#123090341 IN

Site Safety Plan for:
1568 AIR BROADWAY,
NY, NEW YORK

PROJECT:
Alt-2 In Conjunction with Alt-1 At 45 Str
1568 Air Broadway New York, NY 10036,
544' HT Block 999, Lot 9062, CB 105
Alt1 Job # 121191236,
Alt2 Job # 123090341
BIN: 1085494

coordinate with Demo disapproved comments

PHASE 1 STRUCTURAL DEMO SITE
PLAN

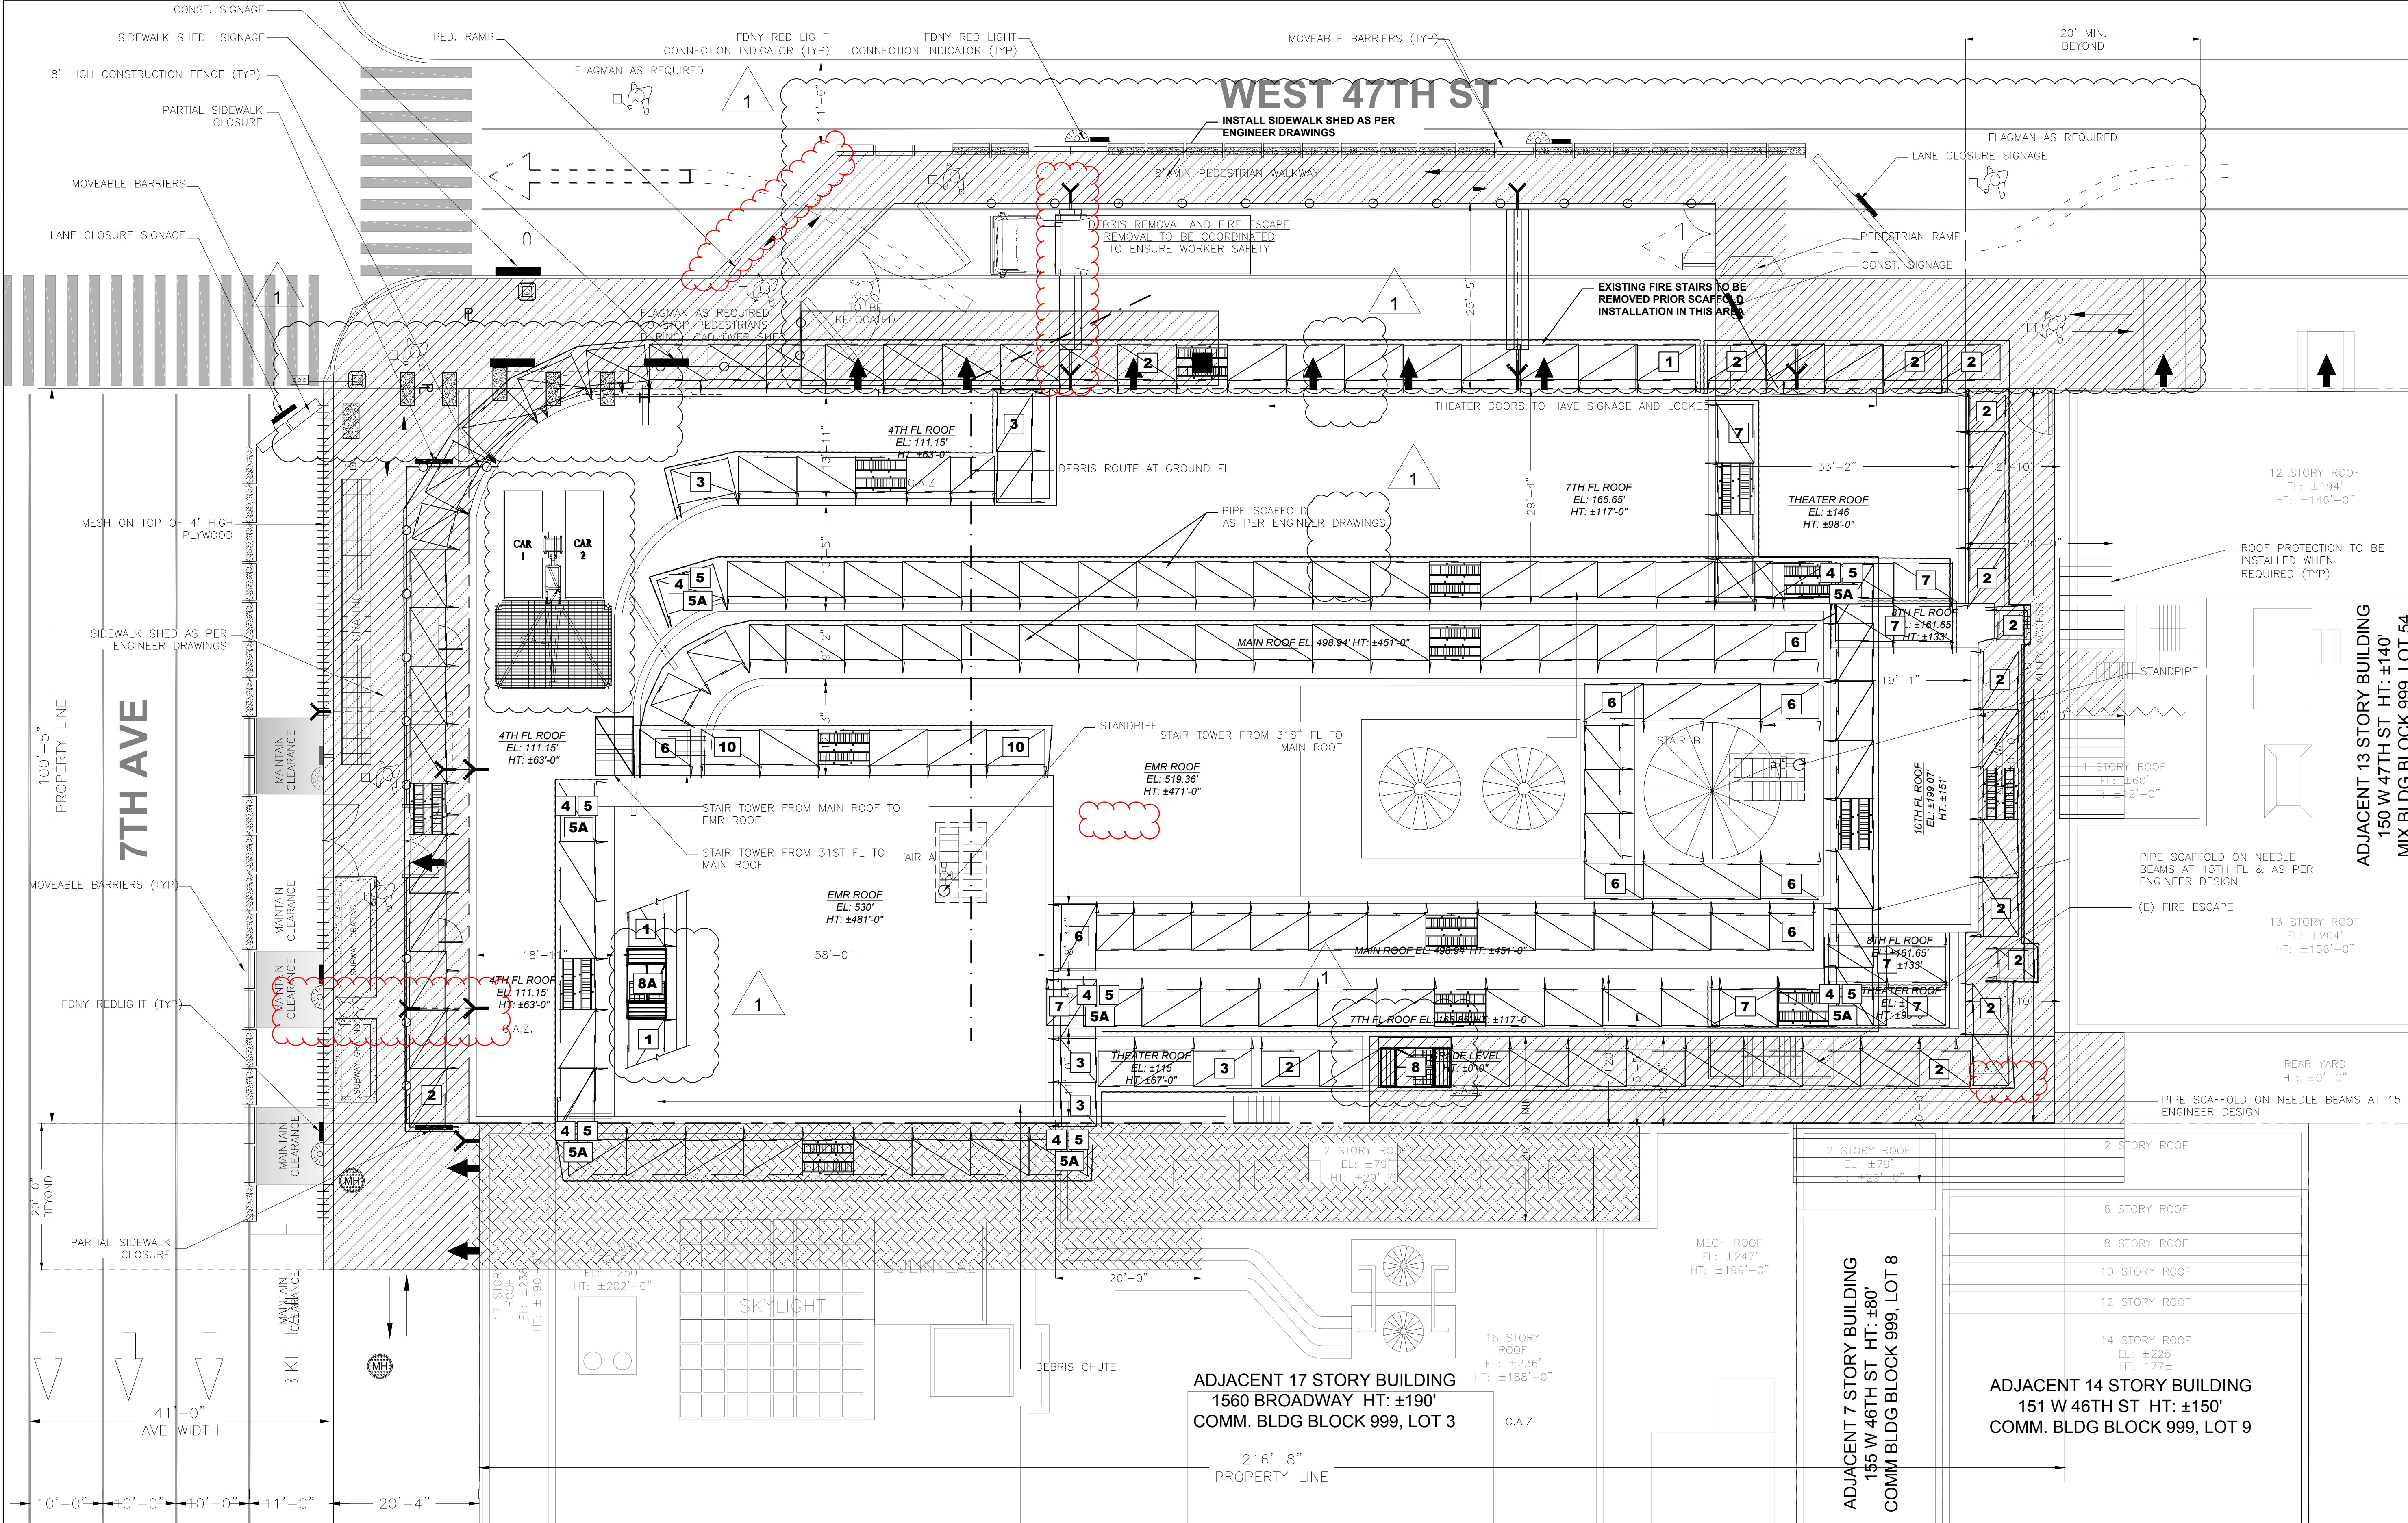
show barriers

clarify location and piping of FDNY connection to extend across equipment/material delivery access area

Provide FDNY letter to be kept on-site at all times for putting a fire hydrant and/or FDNY connection behind a fence

Provide note existing alley is not an accessible means of egress for the existing building or any other adjacent property

show on plan the existing means of egress routes out to the sidewalk

DRAWING TITLE:
PHASE 1 STRUCTURAL DEMO - MECH.
ROOM SECTION

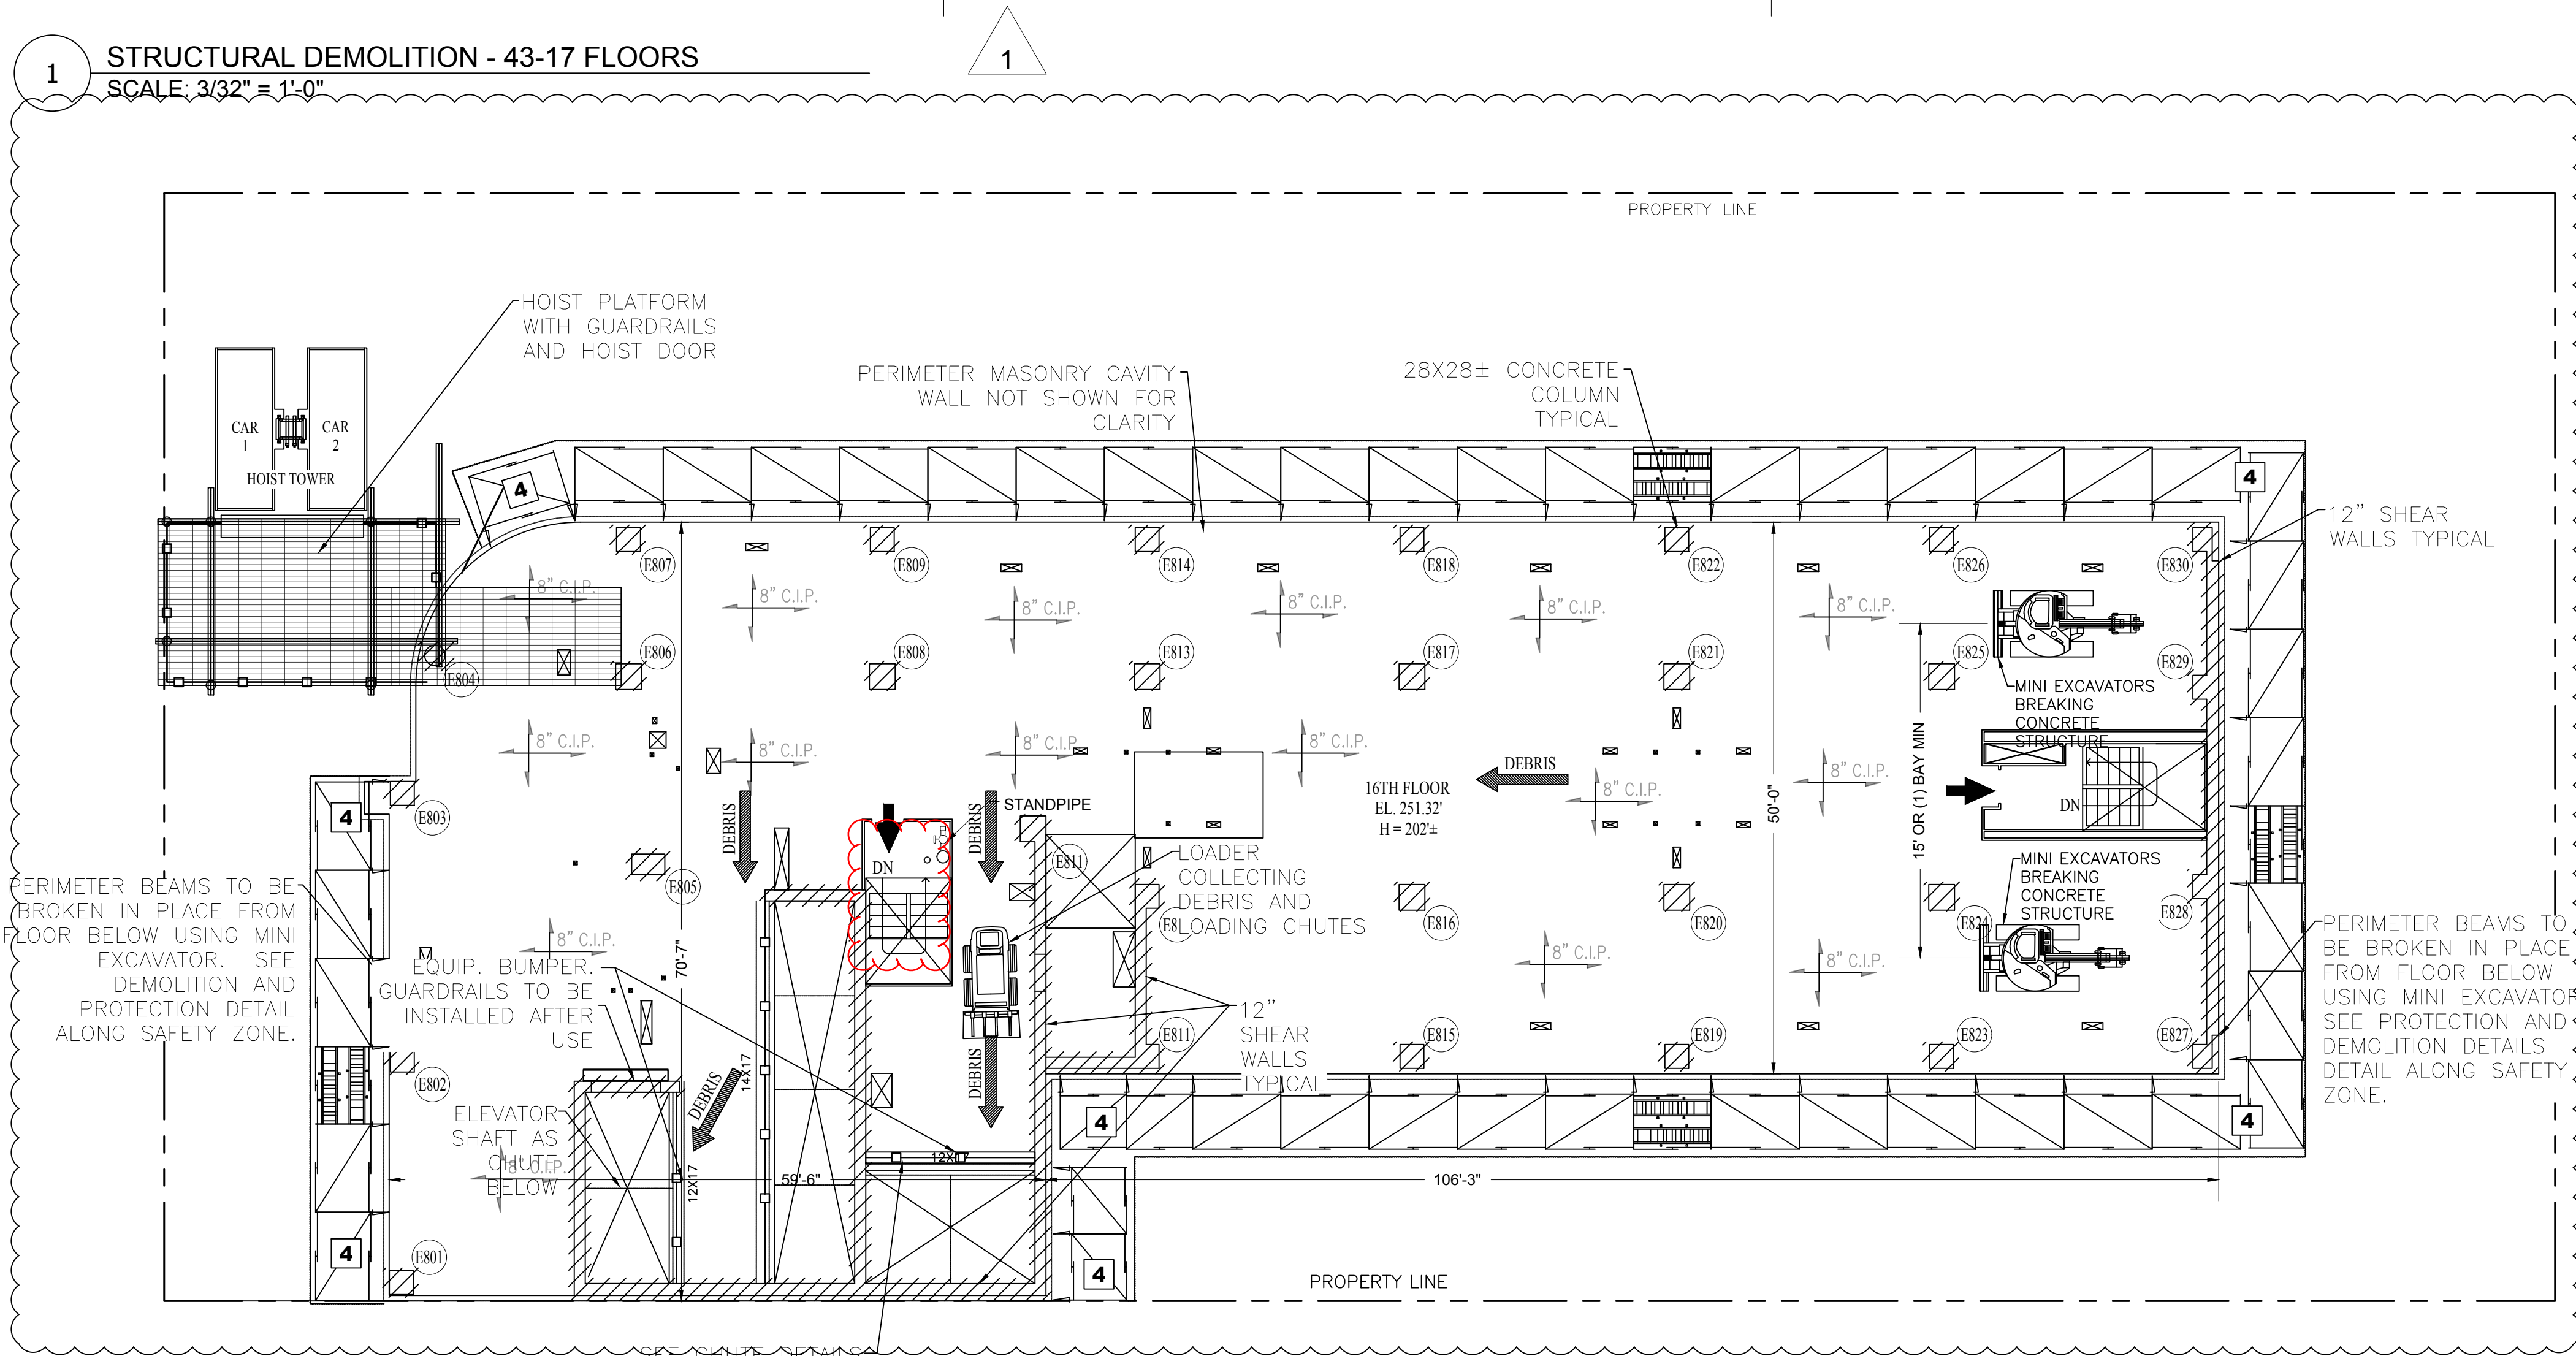
Subject: Cloud
Page: Page 11
Lock: Unlocked
Checkmark: Unchecked
Author: bisleib
Date: 9/4/2018 1:29:33 PM
Show all standpipe locations. cap at floor below
demo floor.

Subject: Cloud
Page: Page 11
Lock: Unlocked
Checkmark: Unchecked
Author: bisleib
Date: 9/4/2018 3:32:03 PM
show exclusion zone for demo equipment to kept
clear of exterior wall
